ADDENDUM NO. 1

**Administration Building Renovation Re-bid
Compton Community College District**

tBP Project. No. 20987.00

tBP/ARCHITECTURE

drawing title:
SITE DETAILS
/ ACCESSIBLE PARKING
drawing no.:
AS-2
drawing of

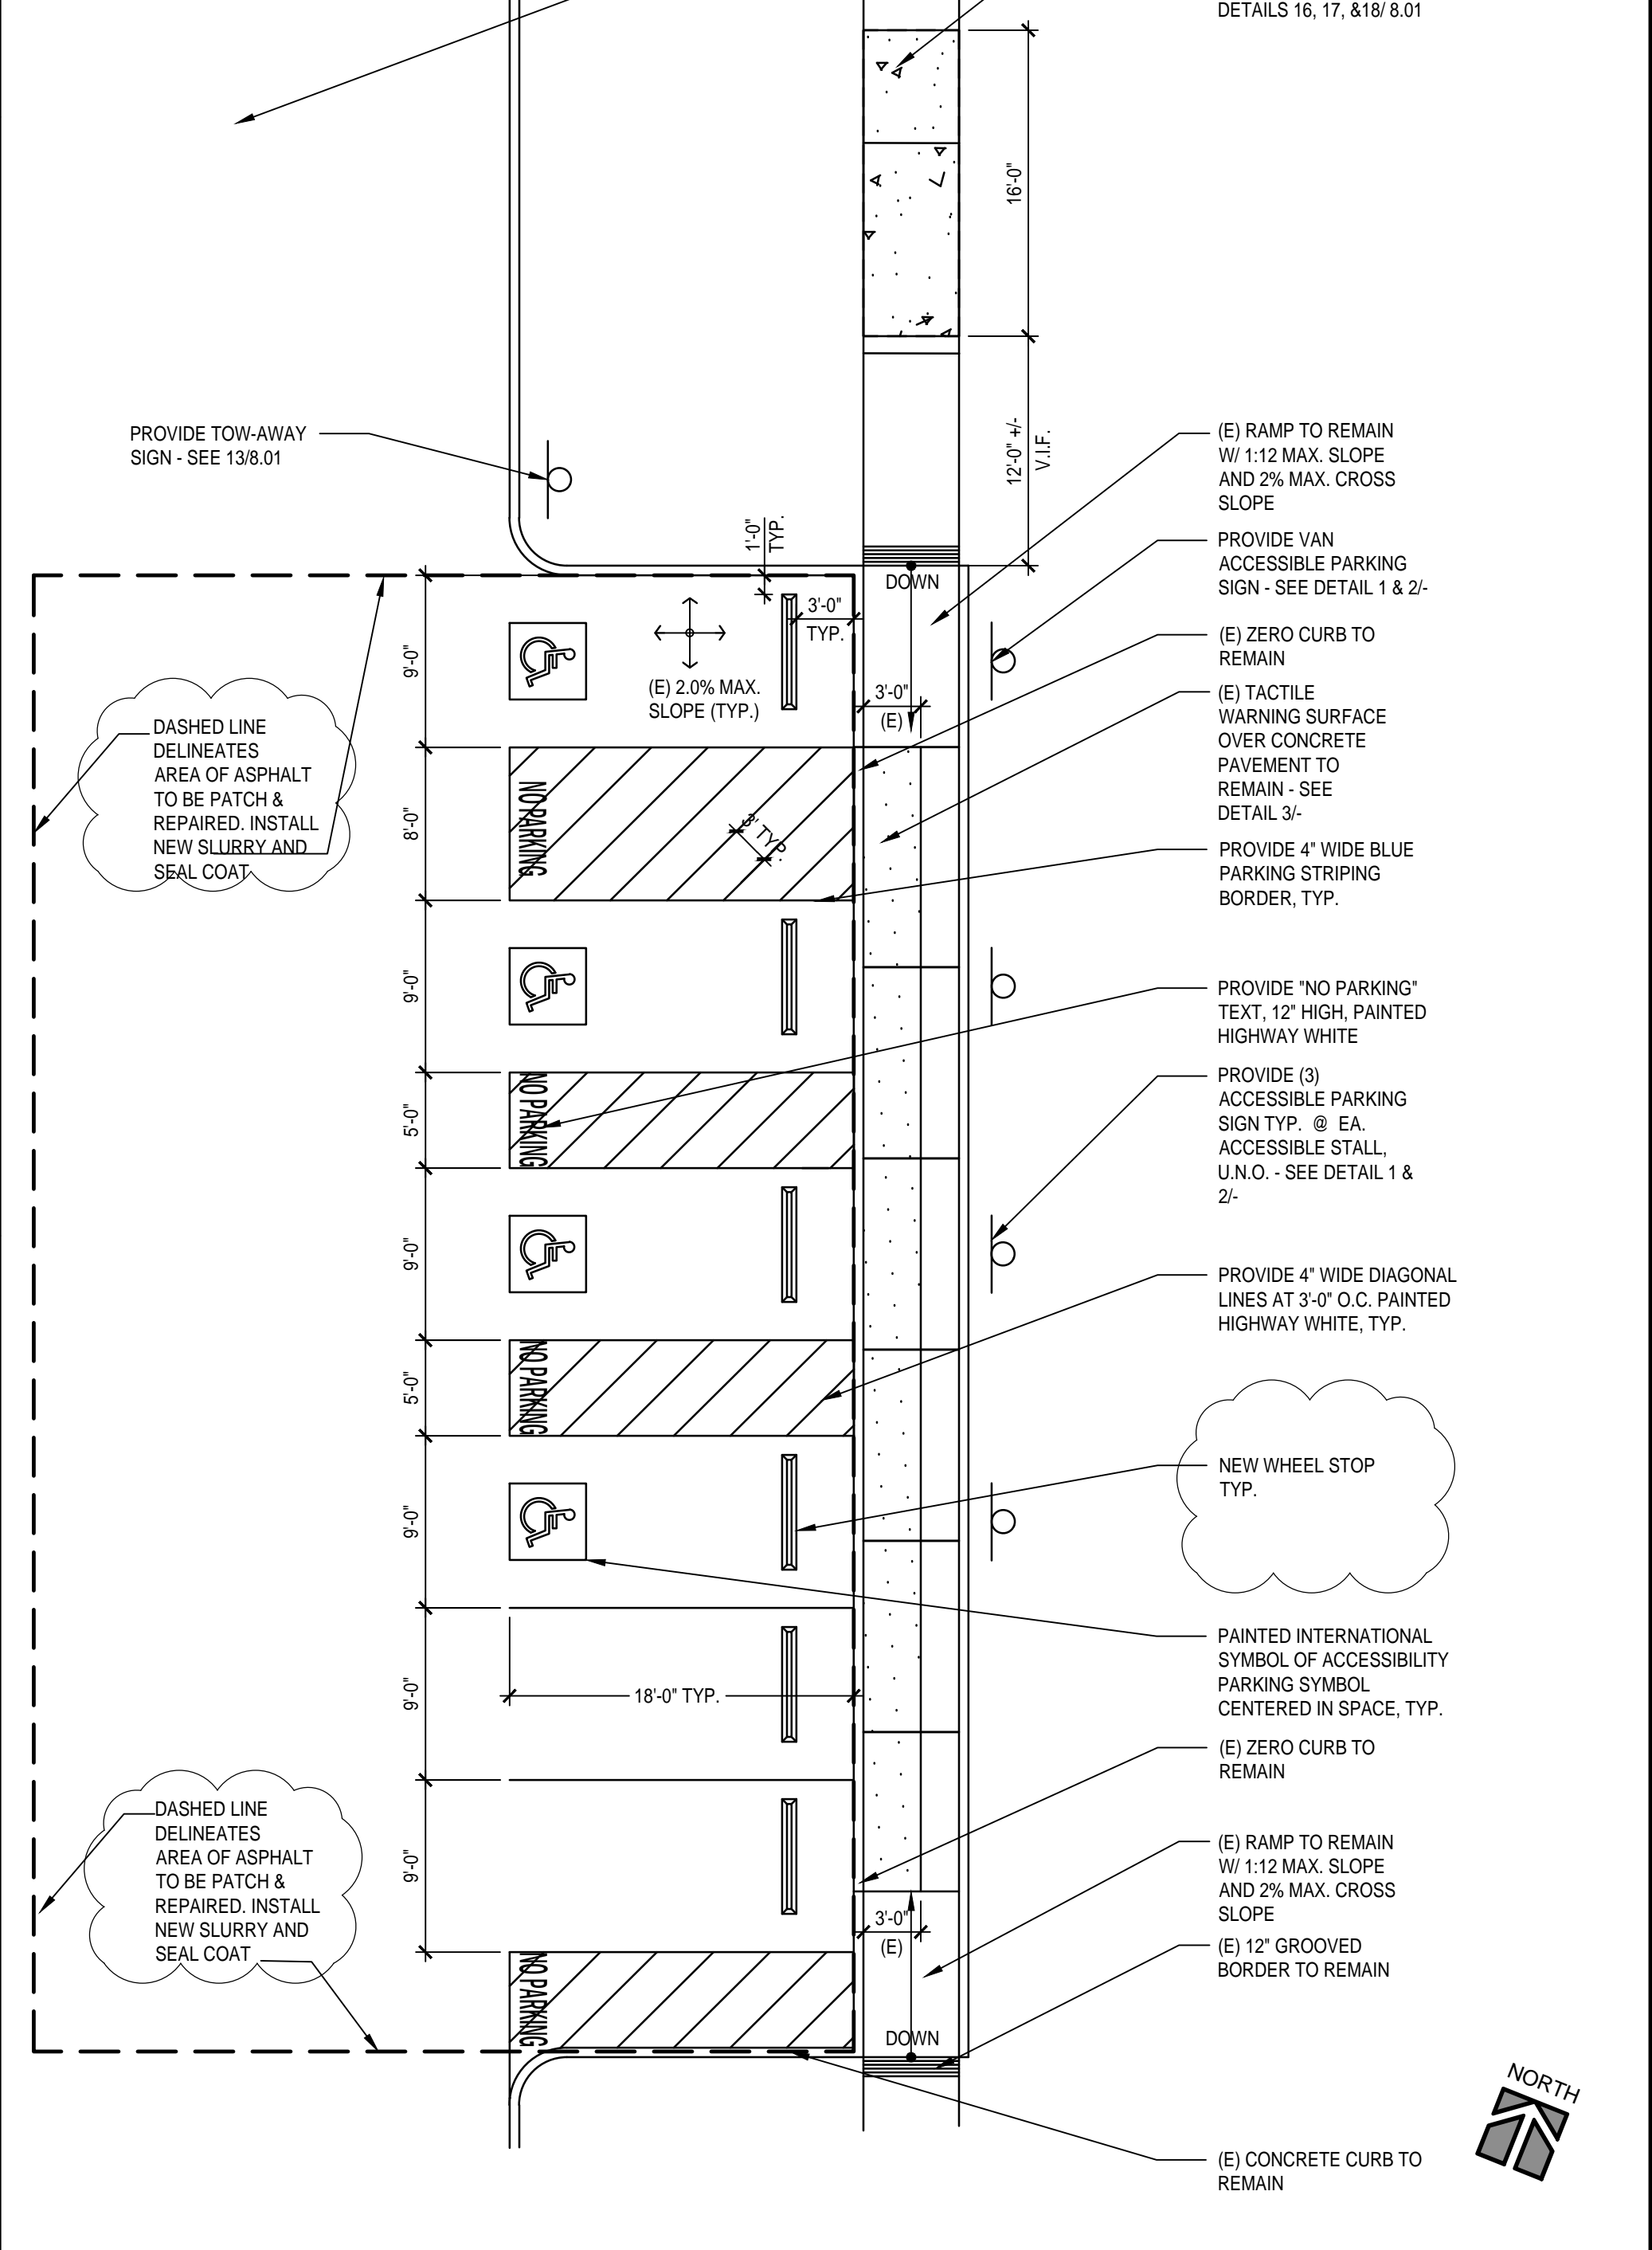
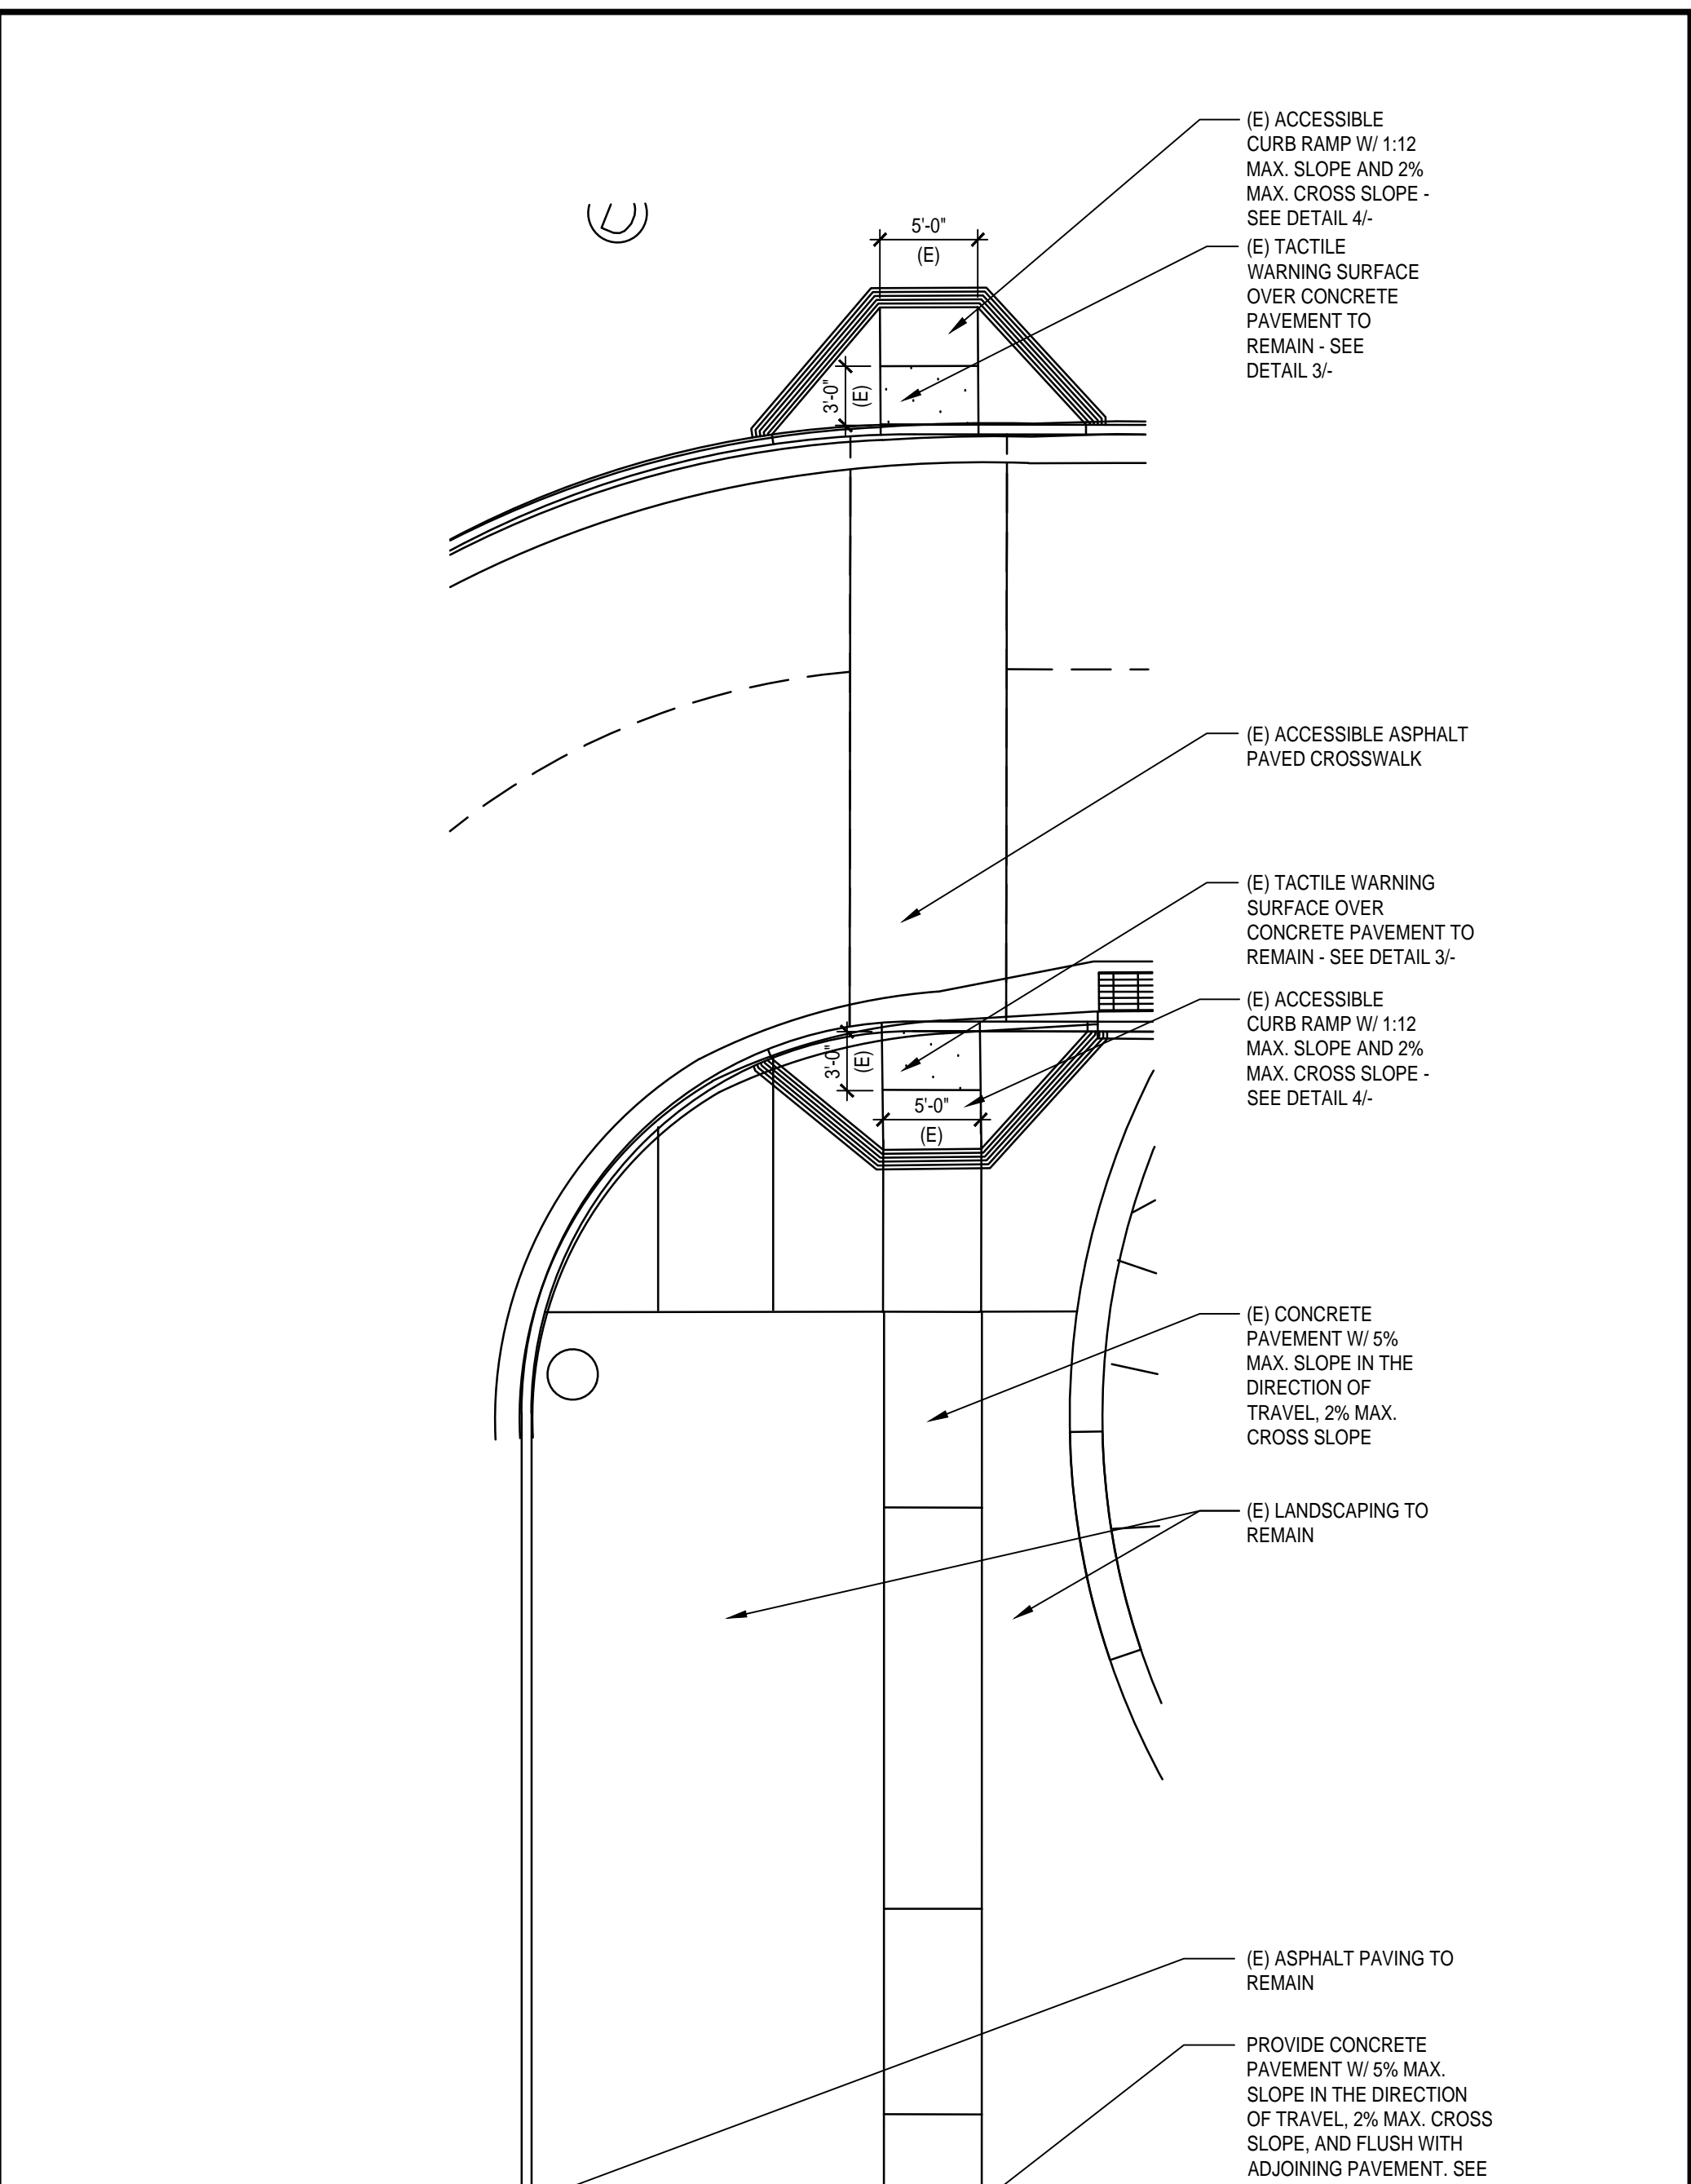
1. Revised SHEET AS-2 SITE DETAILS AND ACCESSIBLE PARKING

a. Included repair and slurry of asphalt area where new ADA parking is re-

- stripped.
- b. Revised all existing wheel stops to be new.
- c. Corrected detail references.
See attached revised Full size sheet identifying revisions included as part of this addendum.
